**Economic Commission for Europe****Inland Transport Committee****World Forum for Harmonization of Vehicle Regulations****Working Party on Passive Safety****Sixty-fourth session**

**UN Global Technical Regulation No. 7 (Head restraints)****Proposal for Amendment 1 (Phase 2 of the global technical Regulation)****Submitted by the Informal Working Group on the Phase 2 of UN Global Technical Regulation No. 7\***

The text reproduced below was prepared by the experts of the Informal Working Group (IWG) on Global Technical Regulation No. 7 Phase 2 (GTR7-PH2) and proposes provisions on head restraints. The modifications to the existing text of the UN Global Technical Regulation No. 7 UN GTR) (ECE/TRANS/180/Add.7) are marked in bold for new or strikethrough for deleted characters.

**Figure 1-1**  
[Goniometry in the test procedure using apparatus that facilitate the measurement of coordinates.]

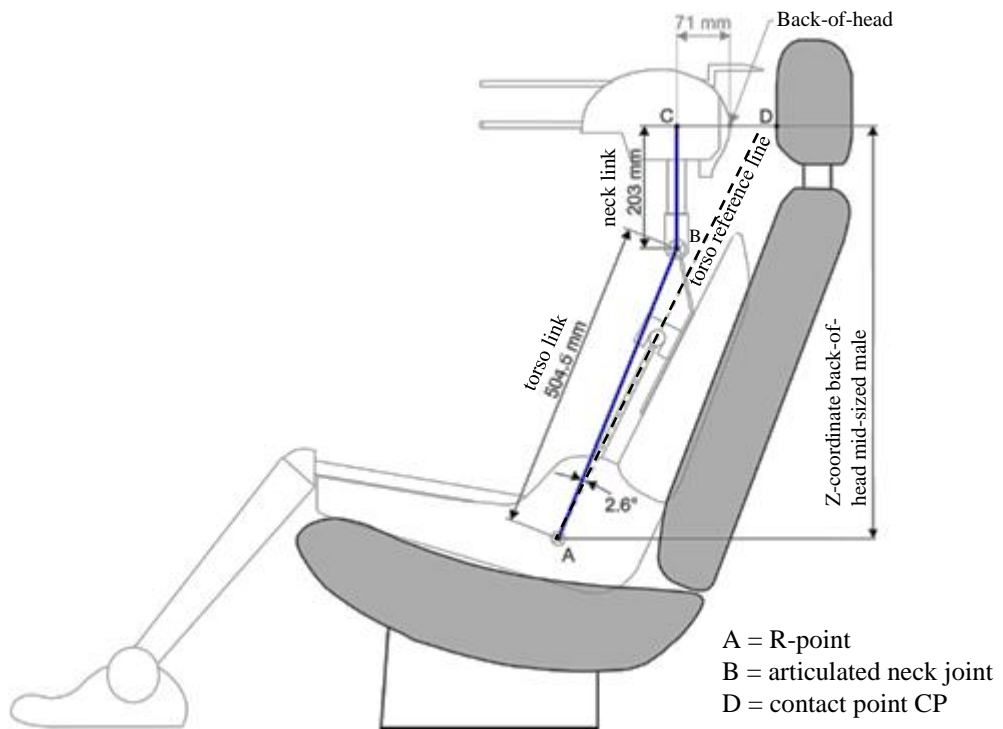
The height measurement apparatus consists of (see Figure 1-1): **is based on the usage of an apparatus that facilitate the measurement of coordinates.**

**Determination of contact point (CP) (see Figure 1-1)**

**The CP is defined as the intersection of a horizontal line, on the height of the Z-coordinate of the back-of-head of the mid-sized male (as given in table 1), with the front surface of the head restraint as indicated in Figure 1-1.**

**Figure 1-2**

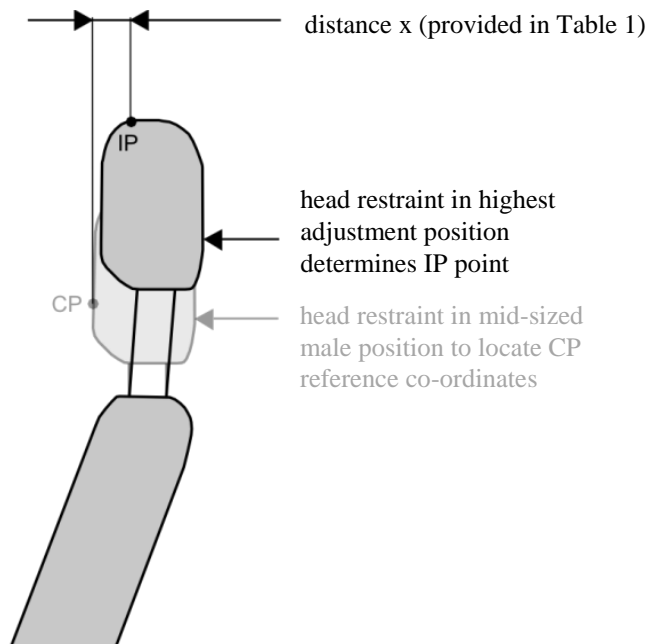
The IP is determined on the front surface of the head restraint as the intersection with a vertical line rearwards of CP (see Figure 1-2) at the "distance x" (as given in table 1).

Figure 1-3

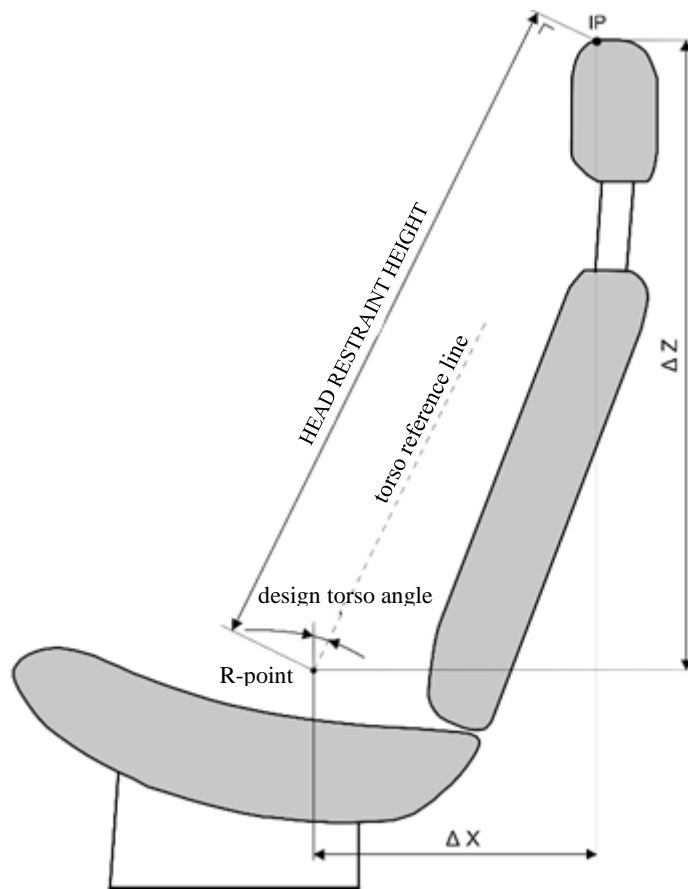
The head restraint height is the distance from the R-point, parallel to the torso reference line and limited by a line perpendicular to the torso reference line intersecting IP (see Figure 1-3).

After the coordinates of IP are determined, the highest head restraint height can be calculated by its longitudinal ( $\Delta X$ ) and vertical ( $\Delta Z$ ) distance from the R-point (see Figure 1-3), as follows:

Figure 1-4

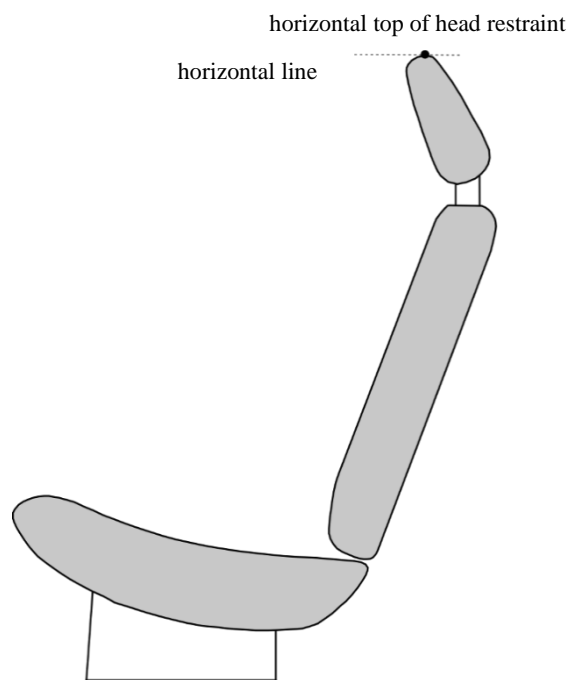
Where IP would be located rearwards of the [horizontal top] of the head restraint, IP will be designated at the horizontal top of the head restraint (see Figure 1-4).

Figure 1-5

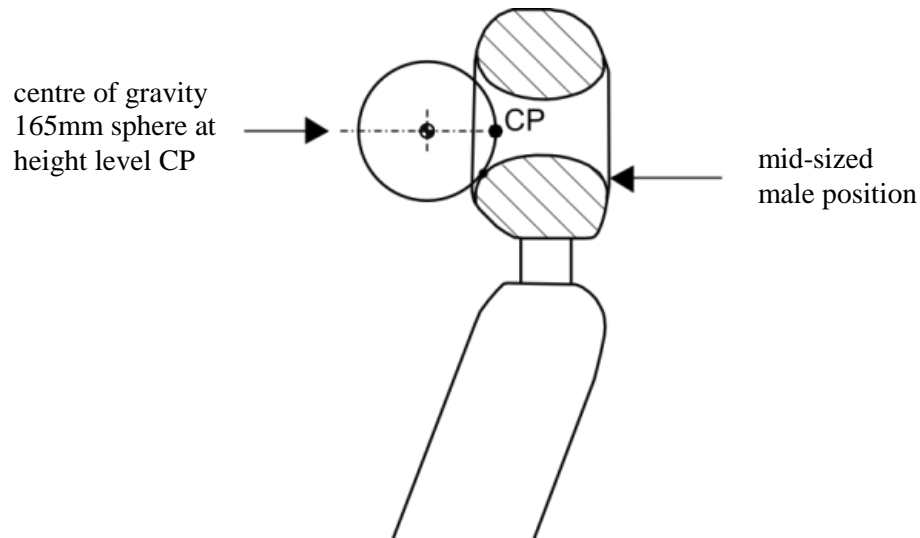
When the sphere is making first contact with the head restraint, CP is designated as the rearmost point of the sphere in the gap area (see Figure 1-5).

Figure 4-1

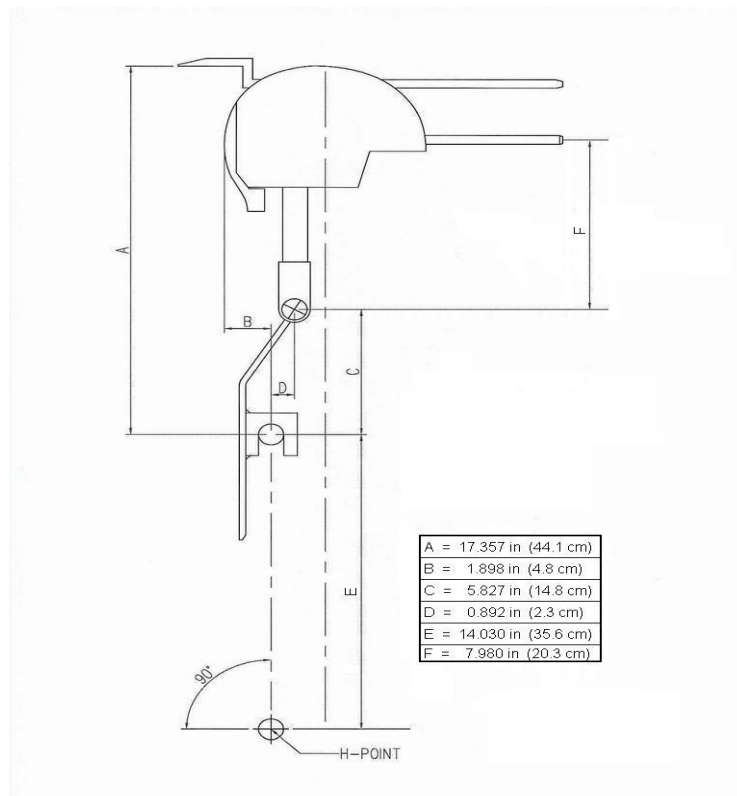
~~Demonstrate compliance with paragraph 5.1.5.2. by measuring the backset of the head restraint using the three dimensional H point machine, defined in Annex 13, and the HRMD (Figure 4-1). This procedure uses the H point as the reference point.~~

Figure 5-2

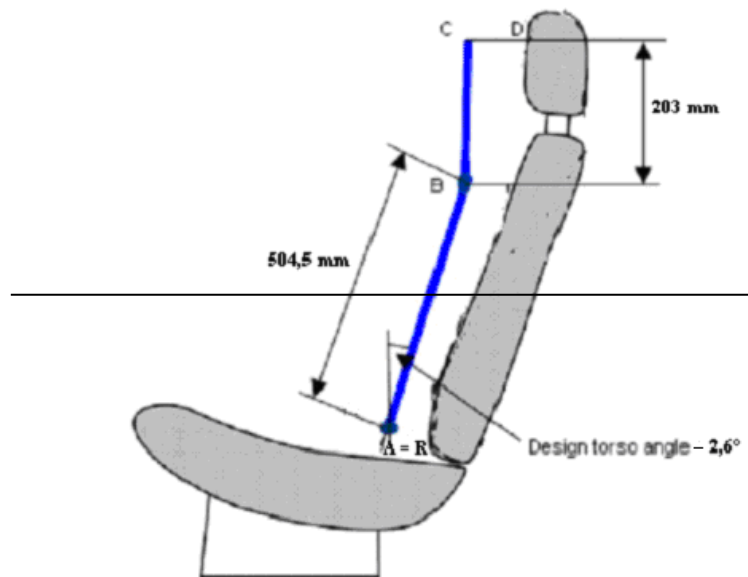
- ~~2.1. Backset measuring apparatus~~  
~~———— The backset measurement apparatus consists of (see Figure 5-2):~~
    - ~~2.1.1. A straight edge (lower arm) AB. The lower point A is placed at the R-point location. Point B is located at a distance of 504.5 mm from the R-point. The line AB is 2.6 degrees forward of the design torso angle.~~

**Measure the X-coordinate of point D. The R-point backset is the difference between the X-coordinate of point D and the X-coordinate of the back-of-head of the mid-size male as given in Table 1 of Annex 1.**

Figure 9-1

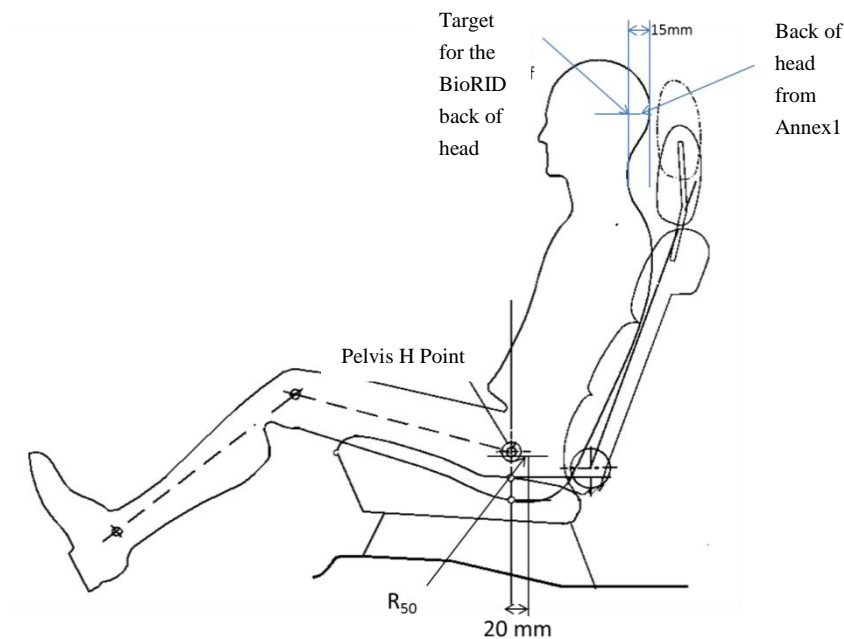
The back of the head reference position for the BioRID II UN is the value for the back of the head as determined for the 50 percentile in table 1 annex 1 of this Regulation with reference to the specified torso angle minus 15 mm (increasing the backset as shown in figure 9-1 *below*).

**Figure 9-3**  
Acceleration versus time curve and Permissible Range of curve for the test set-up according to section 3.2. (The target acceleration with time expressed in milliseconds shall meet the value in the table 9-3.)

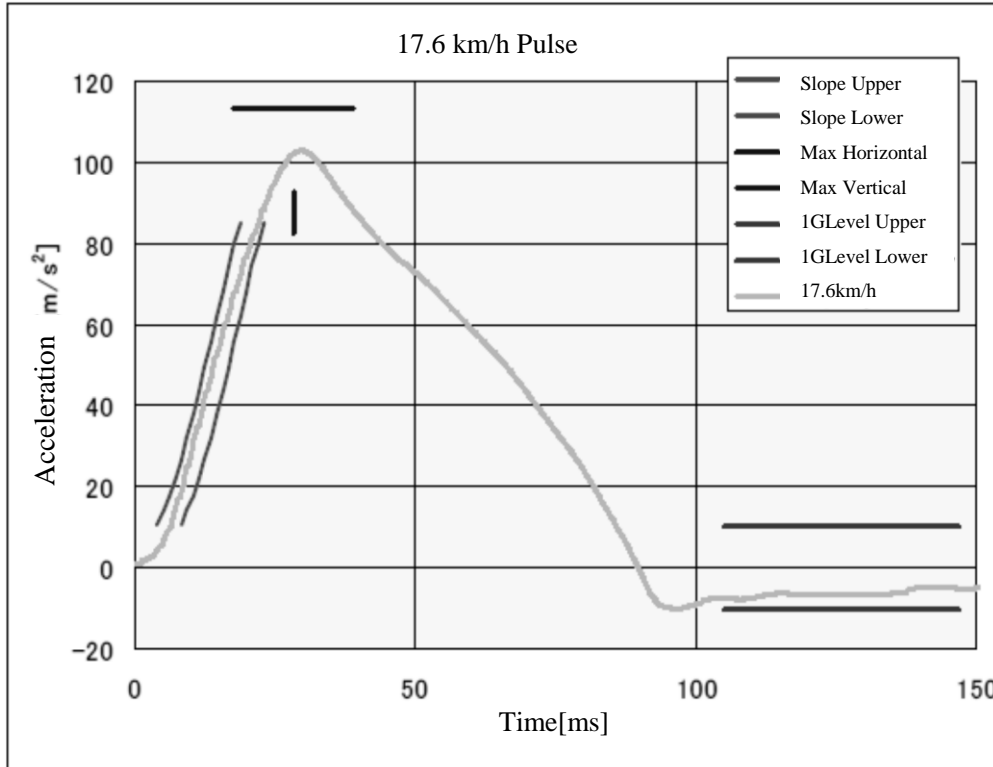
The corridors for the pulse are illustrated in Figure 9-3. [The sled acceleration shall be adjusted within the corridors described in Figure 9-3 and Table 9-2 for the complete time interval from 0 to 0.15s.] The sled pulse shall fulfil the requirements as specified in Table 9-3.
